**ADDENDUM
NO. 4**

October 9, 2024

**LOWELL HIGH SCHOOL NATATORIUM ADDITION
AND RELATED WORK**

ADDENDUM FOUR

© GIBRALTAR DESIGN SHEET
B T-102

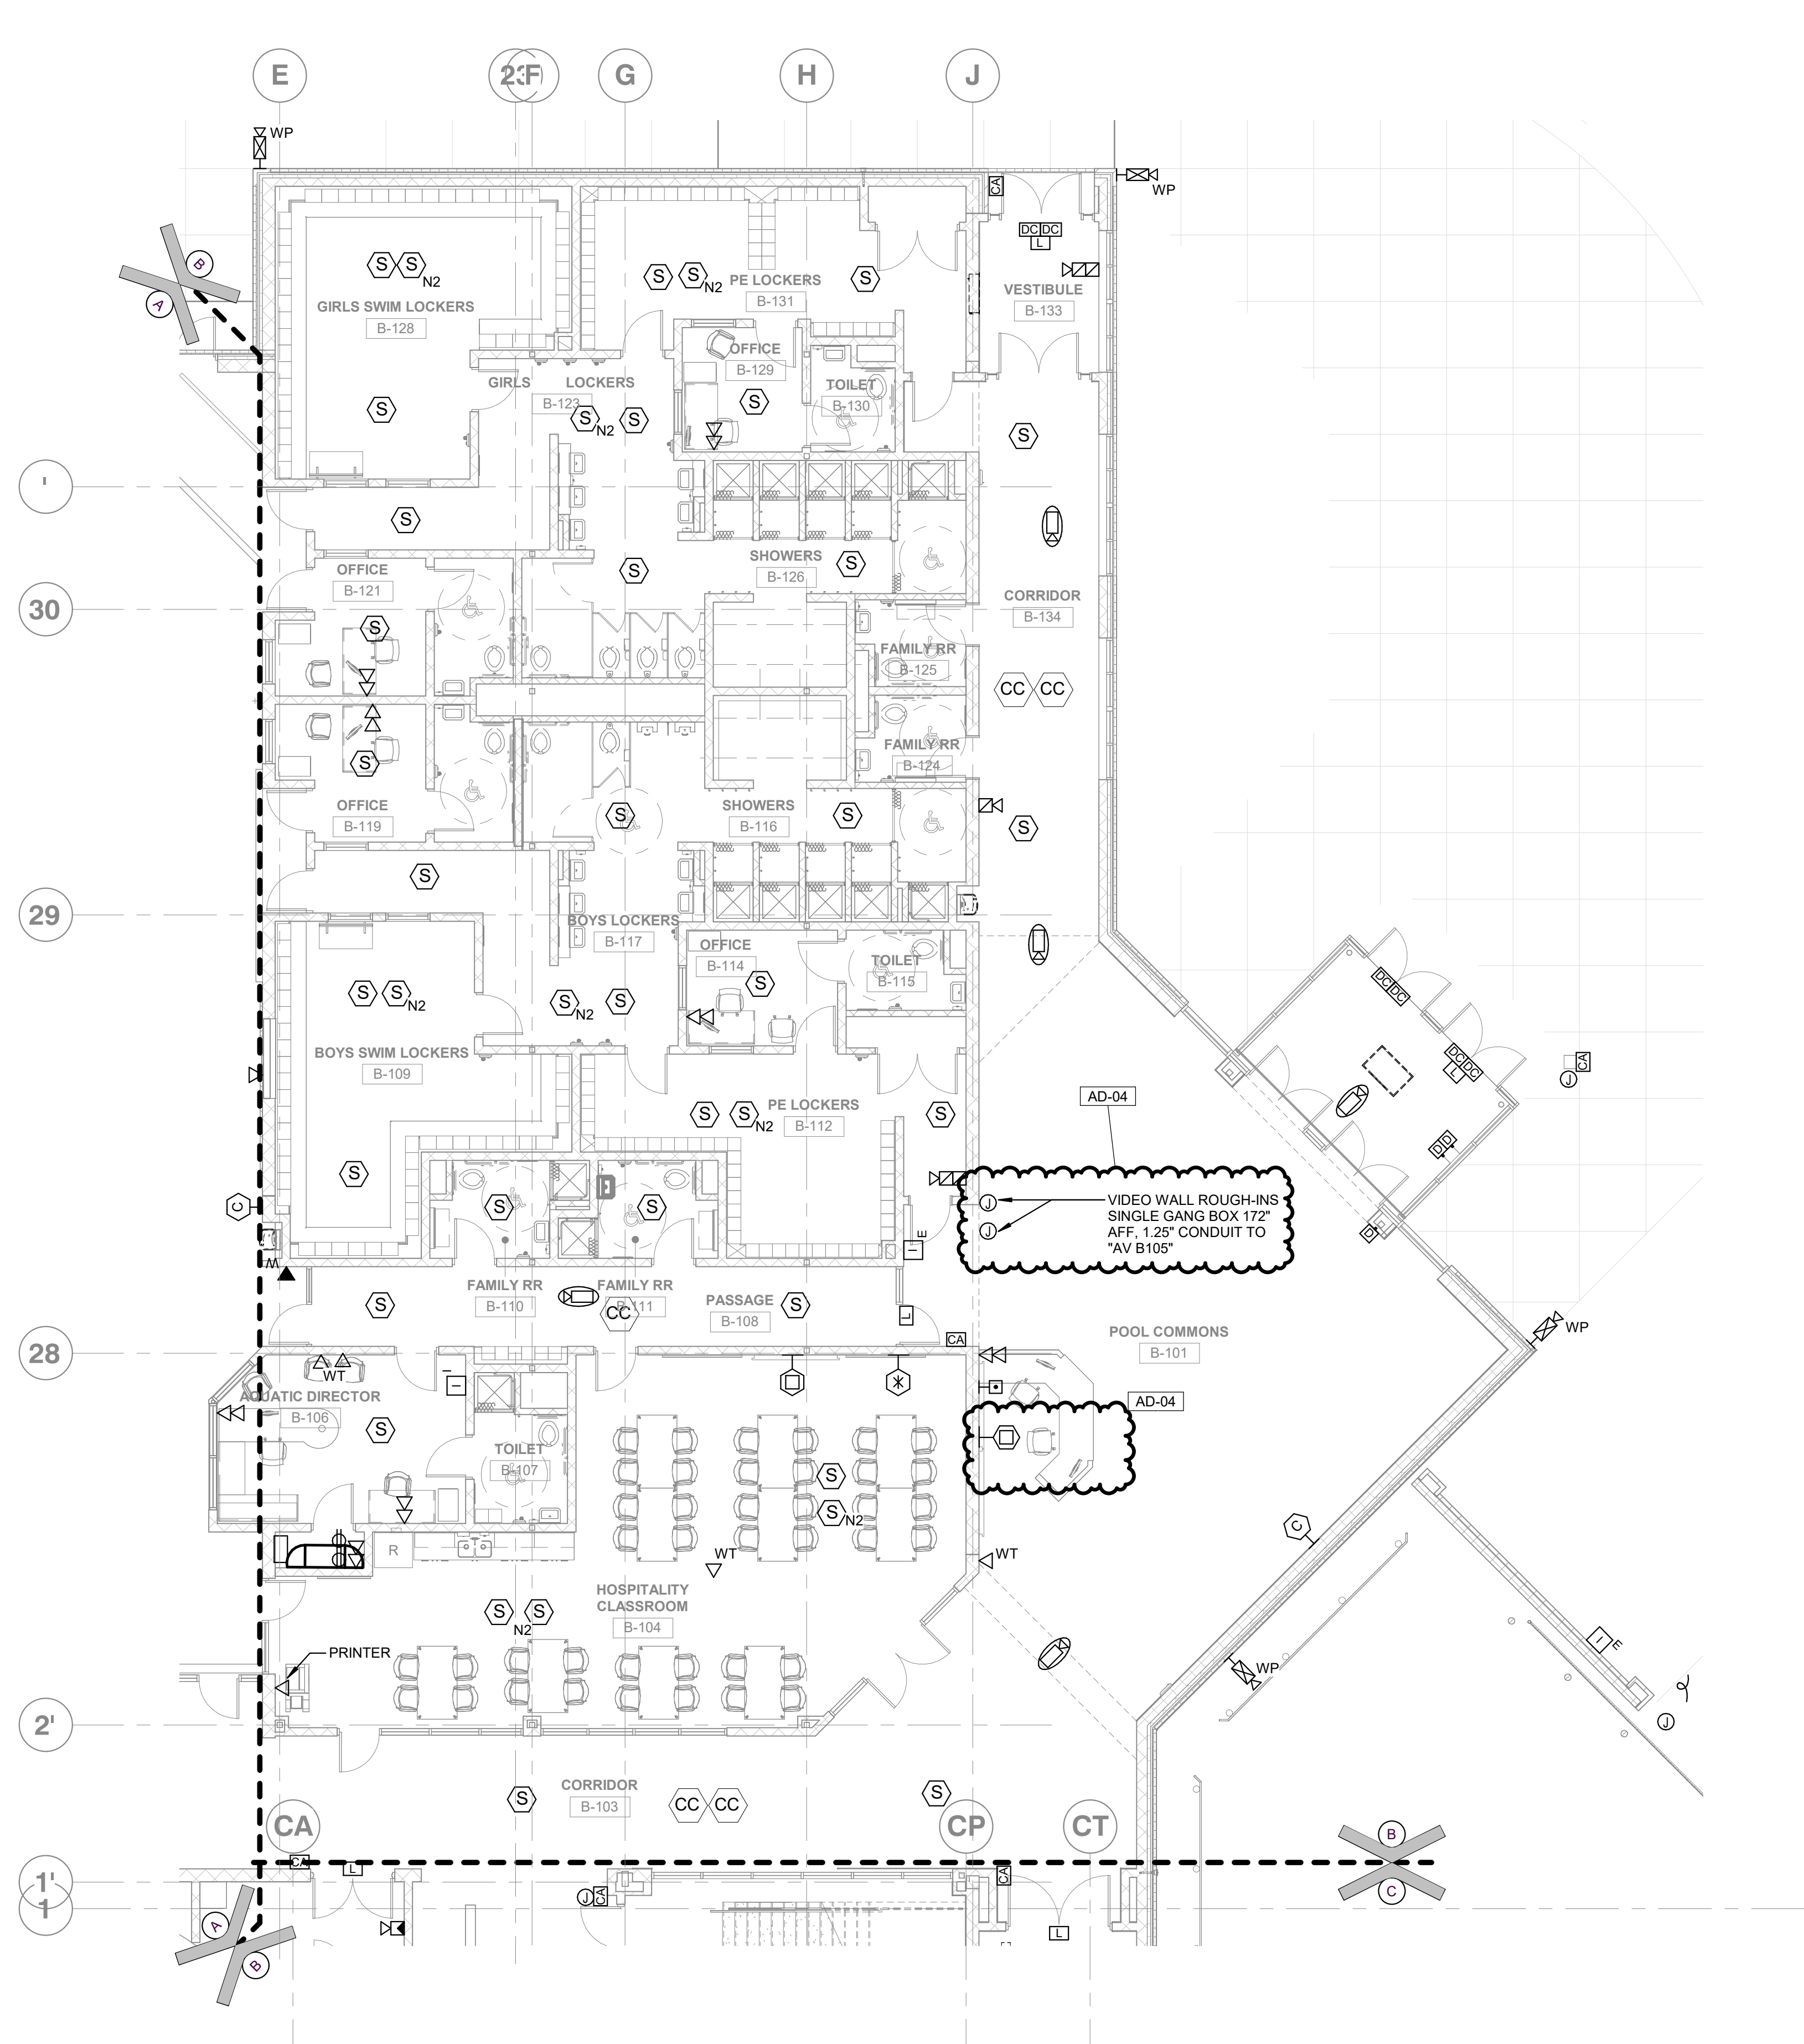
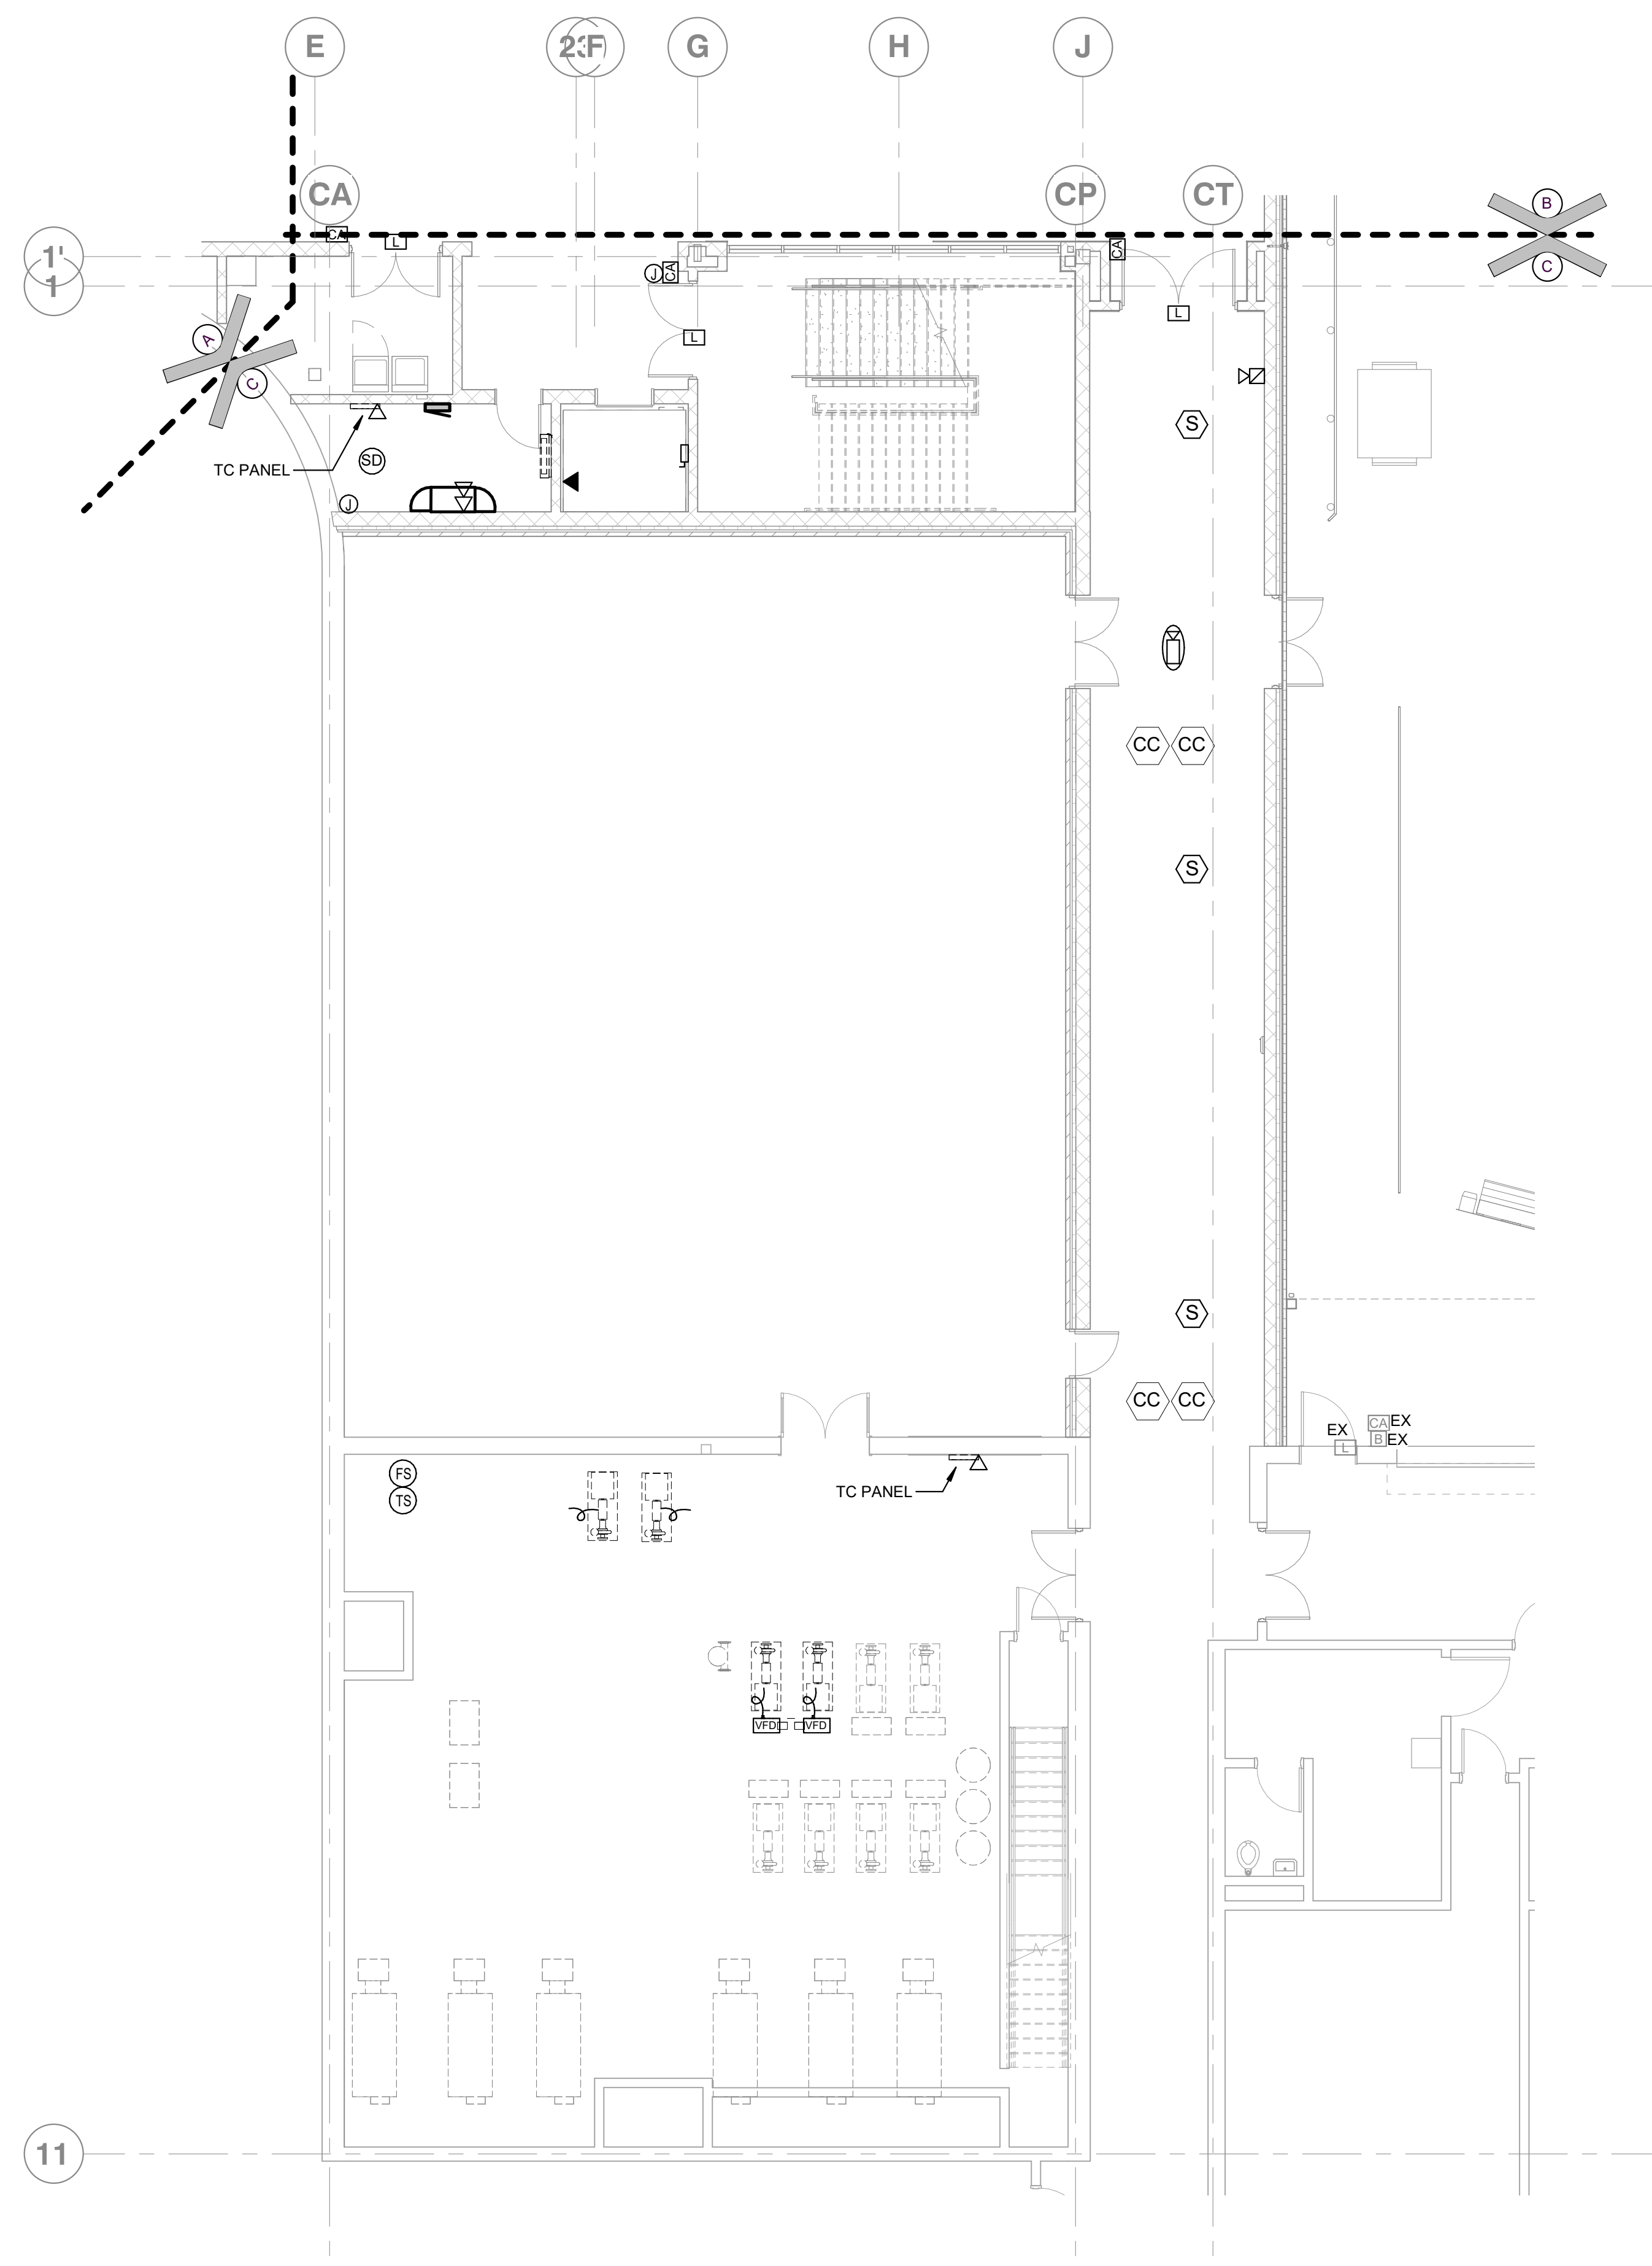
7. Sheet T-102

- A. Refer to revised full size sheet included in this addendum for the following revisions.
 - 1. Revised display locations in commons
